HumeLink

Amendment Report

FIGURE 3-1: Green Hills corridor amendment

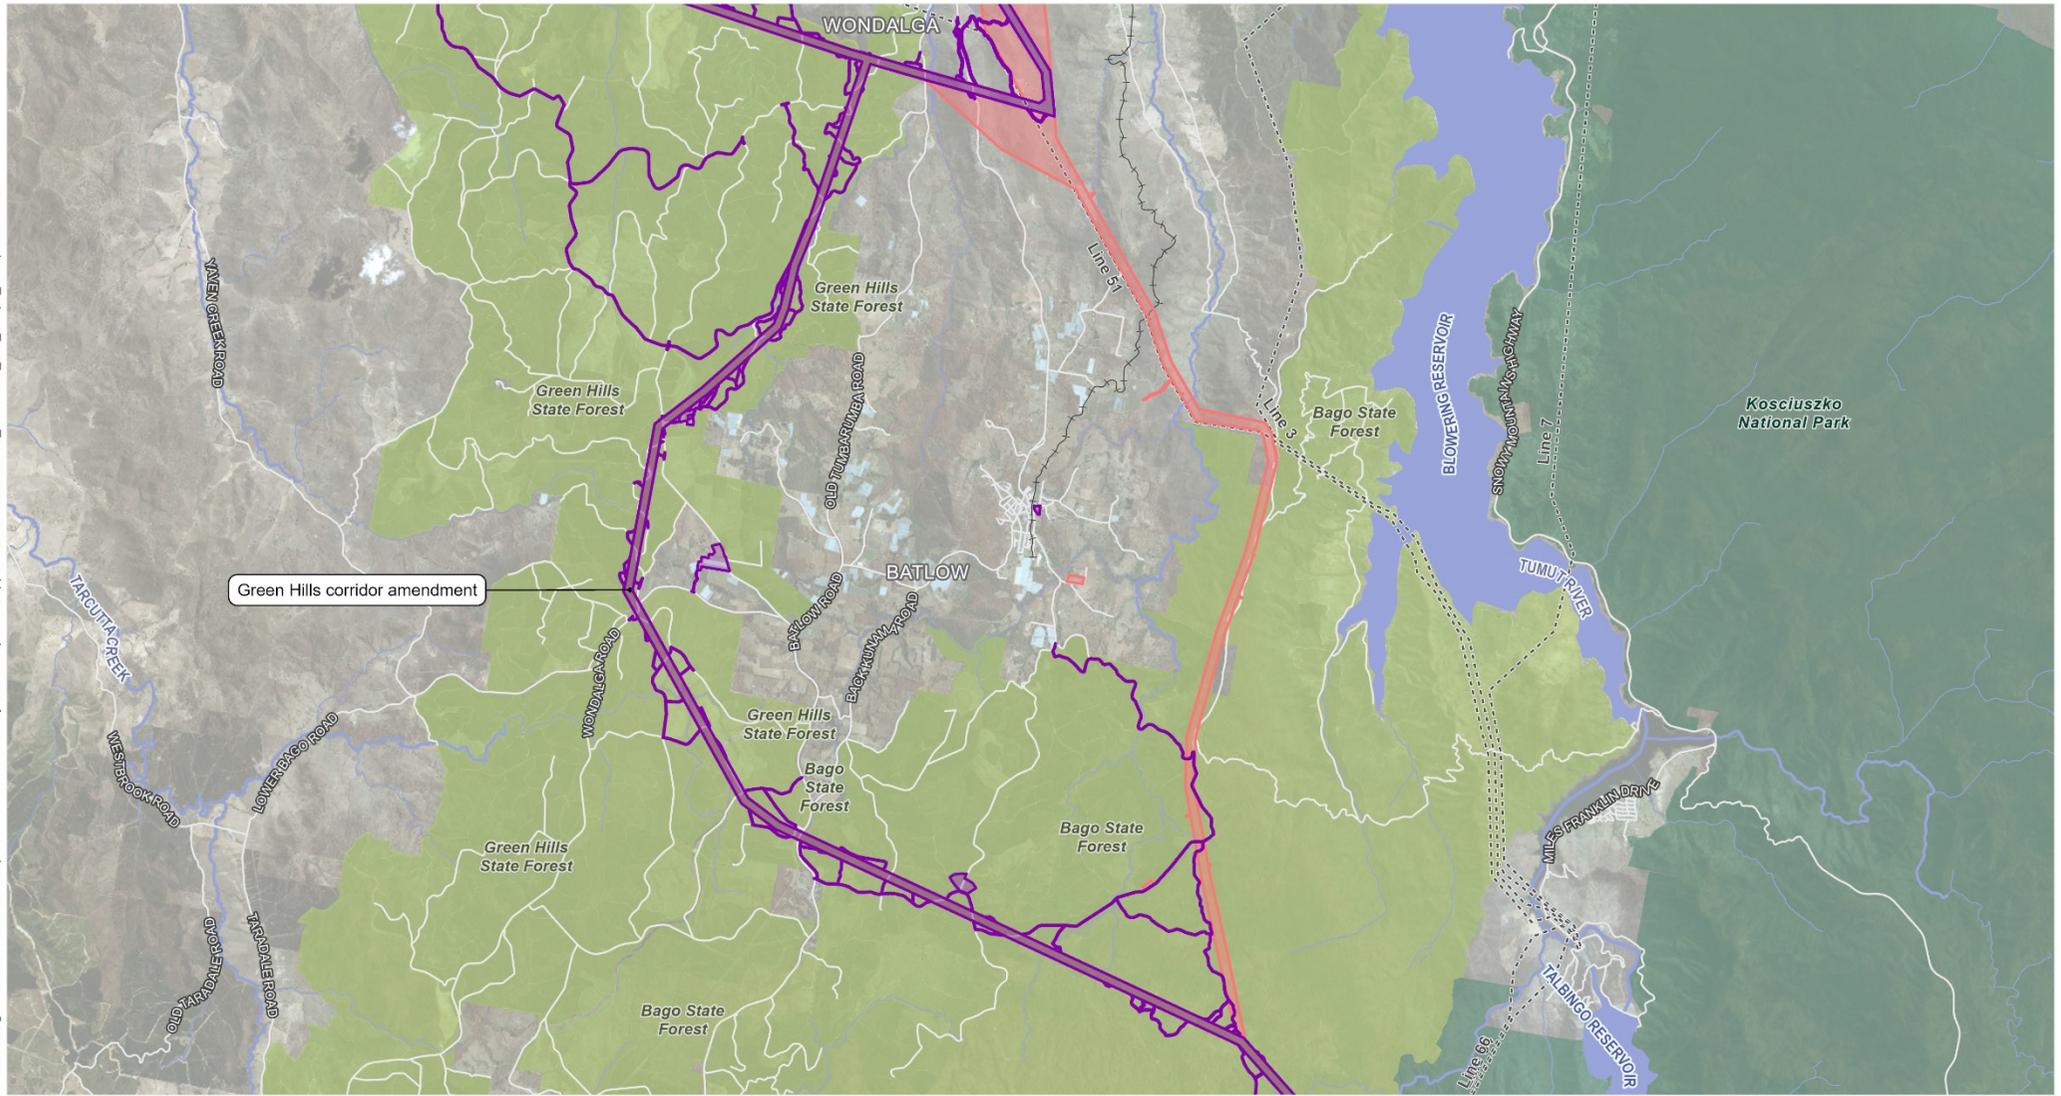
Following additional consultation with affected landowners prior to and during the exhibition of the EIS and further technical analysis and investigations, the alternate transmission line corridor option west of Batlow and through Green Hills State Forest (referred to as the Green Hills corridor amendment) was identified as the preferred option for the transmission line corridor between Wondalga and the future Maragle 500 kV substation.

With this realignment, the transmission line corridor would extend from the west of Wondalga Road and run in a southern direction along the eastern side of Green Hills State Forest for about 21 kilometres, then south-east for around 17.5 kilometres through Bago State Forest before joining the EIS project transmission line corridor near two existing 330 kV transmission lines (Line 64 and Line 66). The transmission line route would be located to the west and south of Batlow and crosses local roads and trails within Green Hills State Forest, Lower Bago Road, Batlow Road, Adelong Creek and Bago Creek. East of Wondalga Road, the transmission line would run south-east for around 4.5 kilometres before turning north. Figure 3-1 provides a comparison of the preferred western route through Green Hills State Forest and the EIS project.

FIGURE 3-2a: Minor changes to transmission line corridor

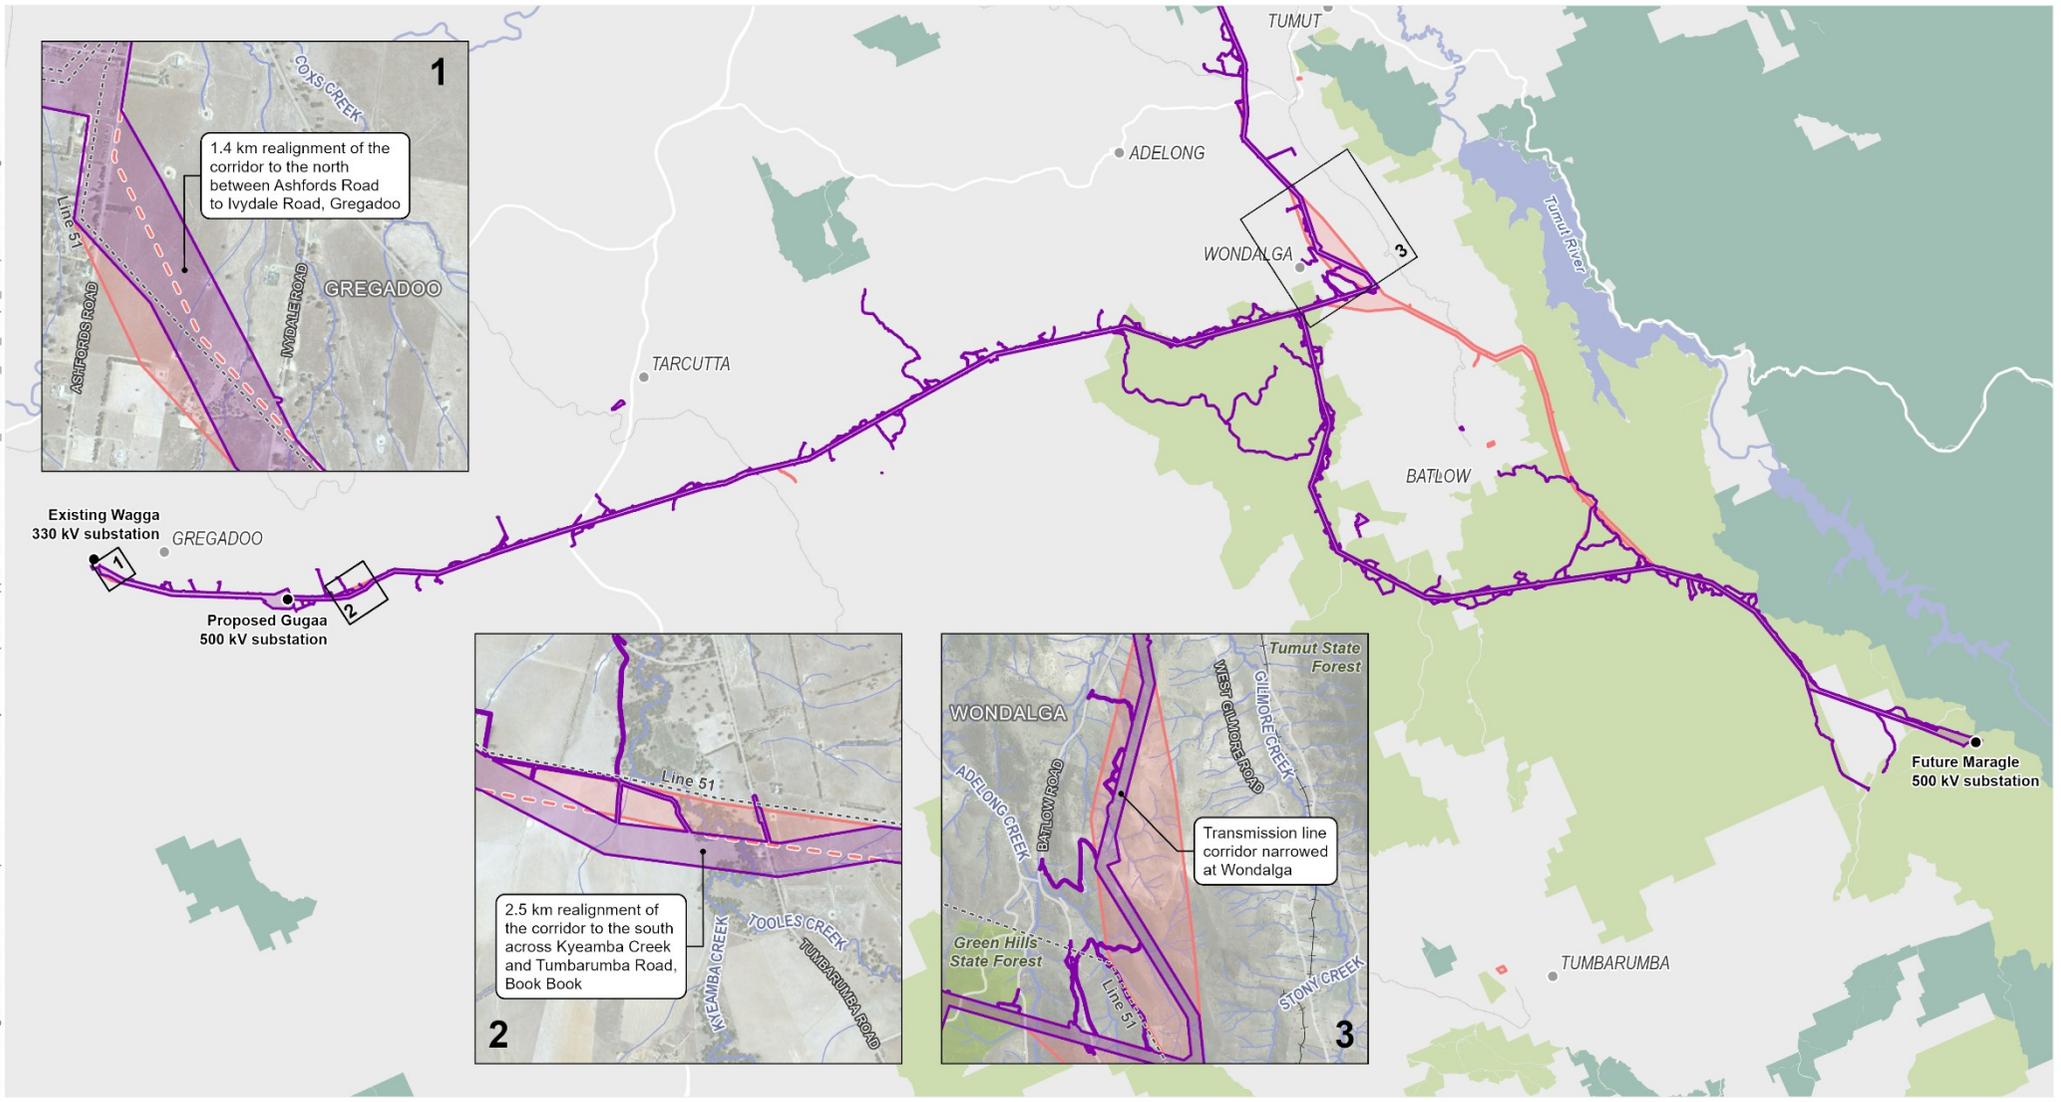
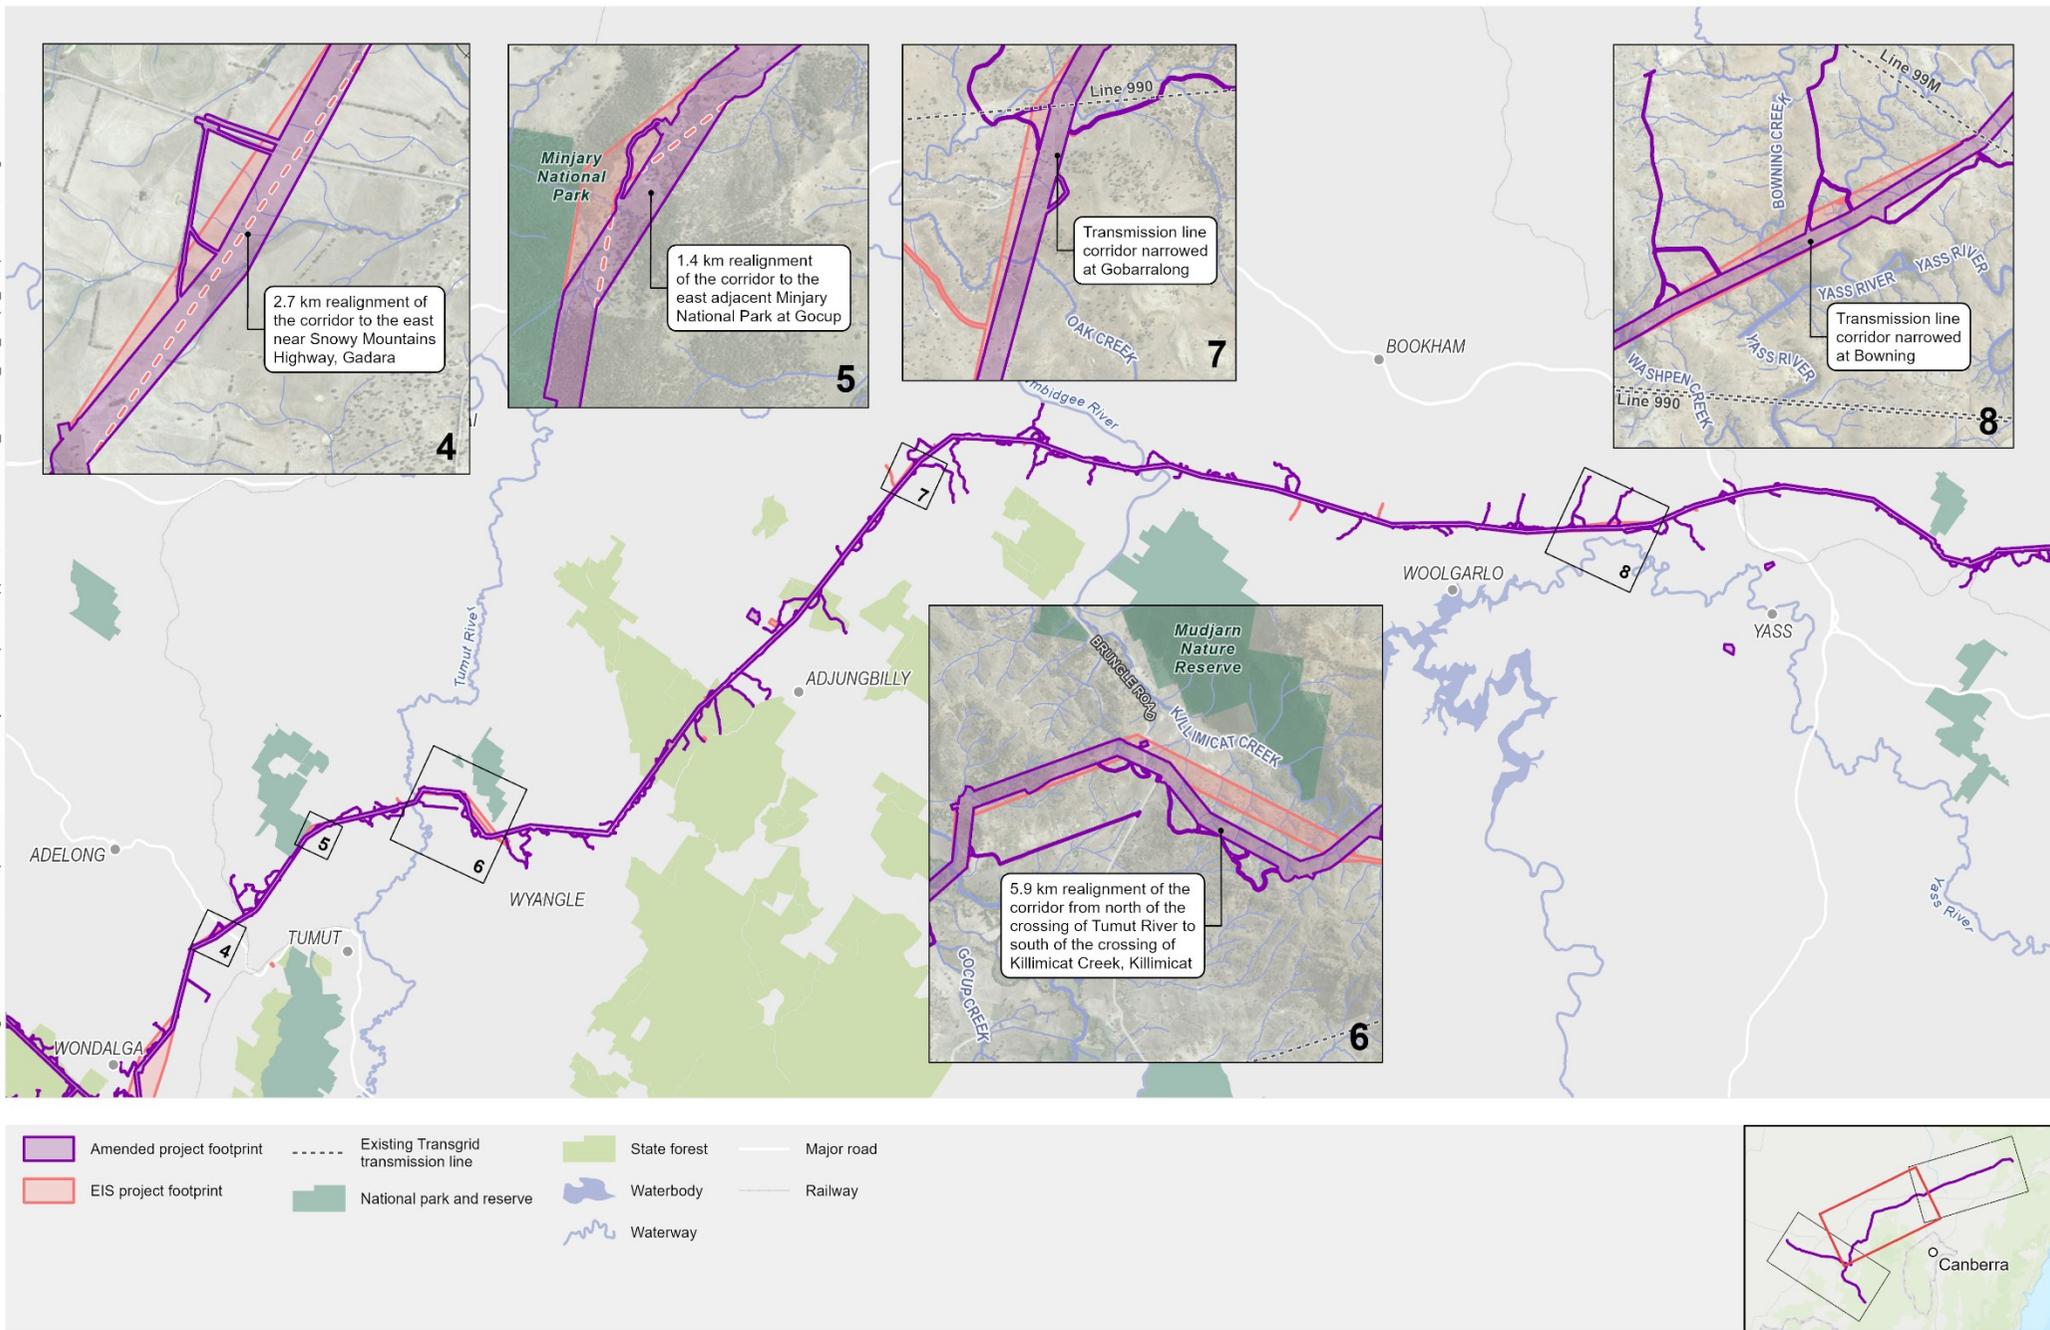
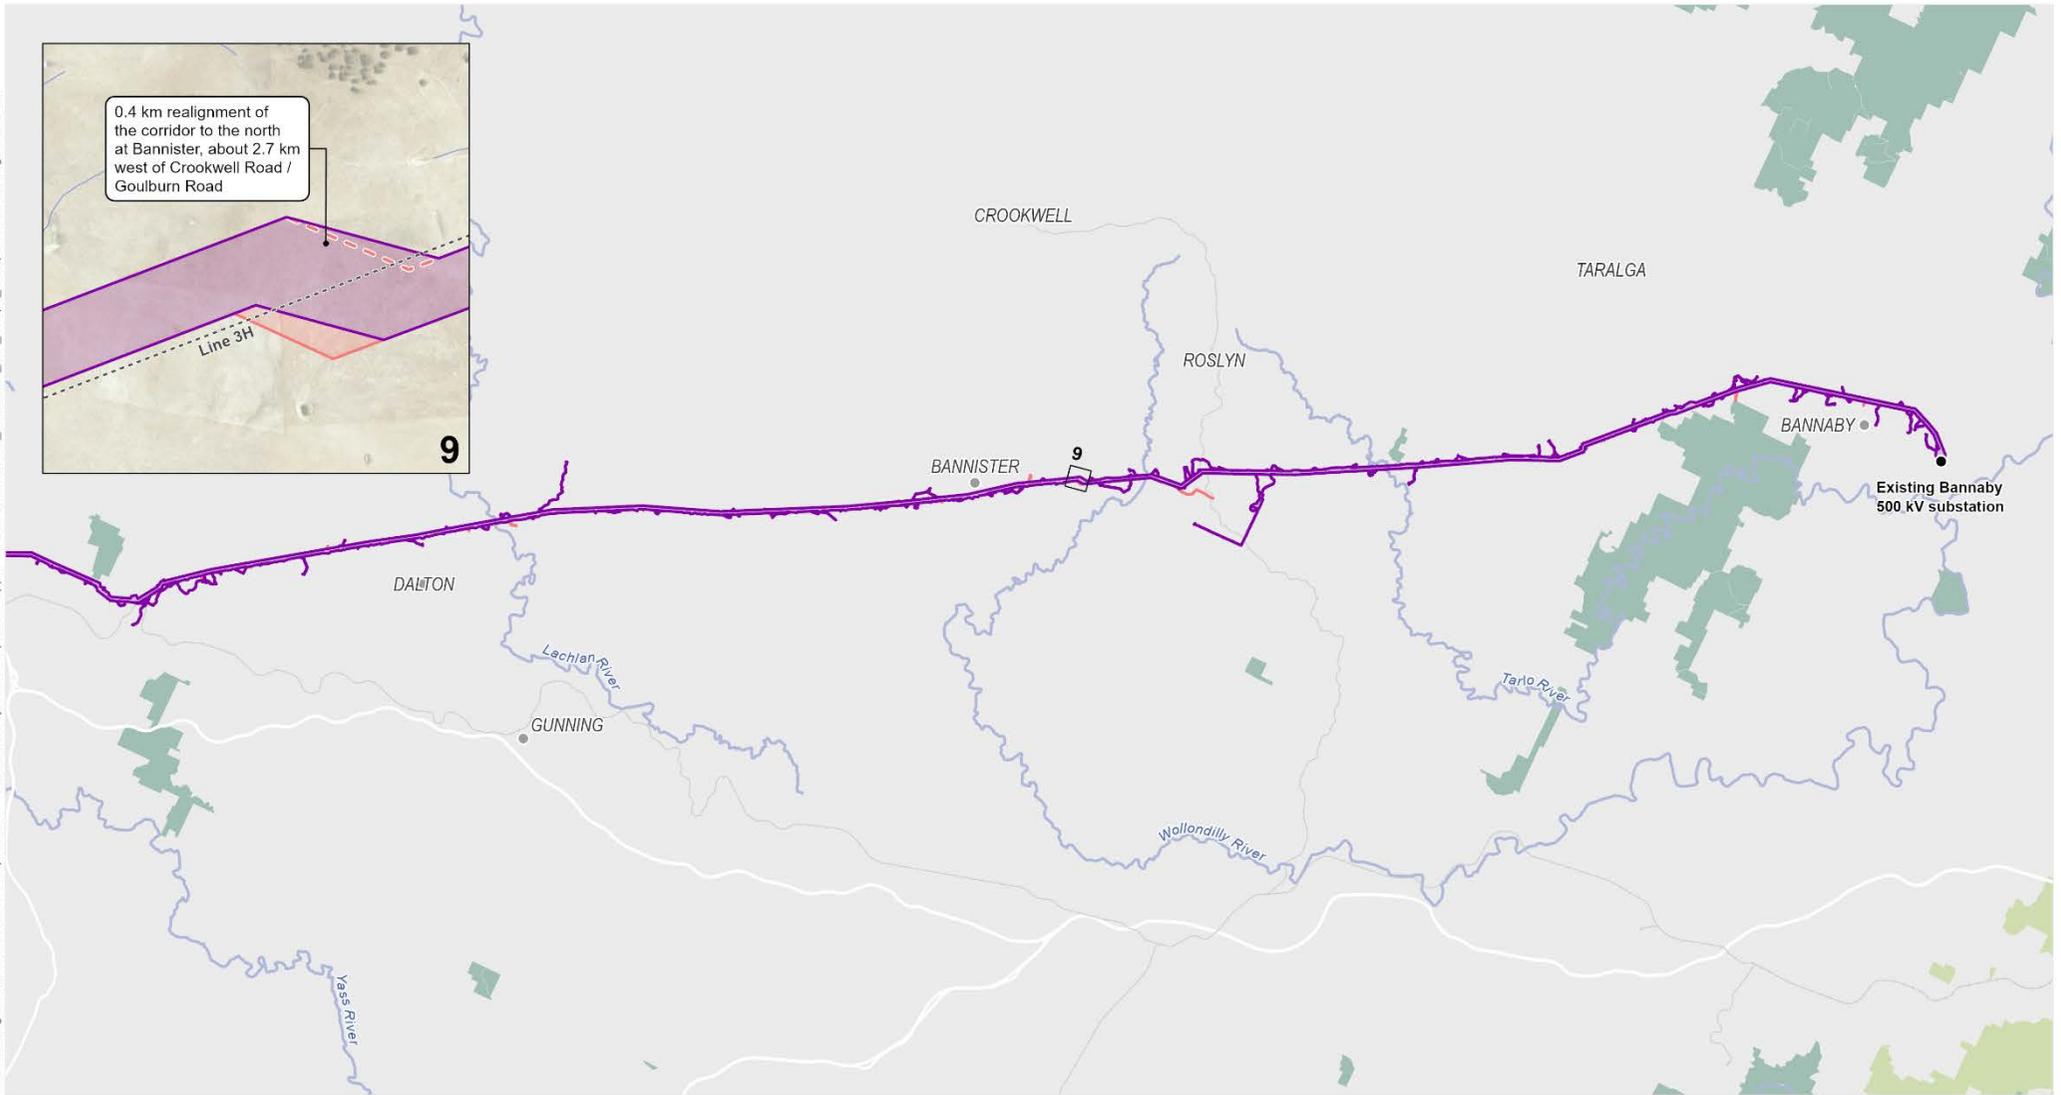
Table 3-2 provides a description of the proposed minor changes to the transmission line corridor and associated EIS project descriptions. Figure 3-2 provides a comparison of these changes and the EIS project.

General location	EIS description	Amendment description
(9) West of Crookwell Road/Goulburn Road at Bannister	From the south, the transmission line corridor extended in a north-east direction and generally paralleled an existing 330 kV transmission line (Line 3H). At about 2.7 km west of Crookwell Road/Goulburn Road, the transmission line corridor deviated from paralleling Line 3H on its northern side to be located on its southern side as it crossed Crookwell Road/Goulburn Road.	Following further design development, which resulted in a reduction in transmission line structures, and subsequent supporting technical and environmental assessment to determine feasibility, a 0.4 km realignment of the transmission line corridor to the north is proposed. The realignment occurs at the location where the transmission line corridor deviates from paralleling Line 3H on its northern side to be located on its southern side.
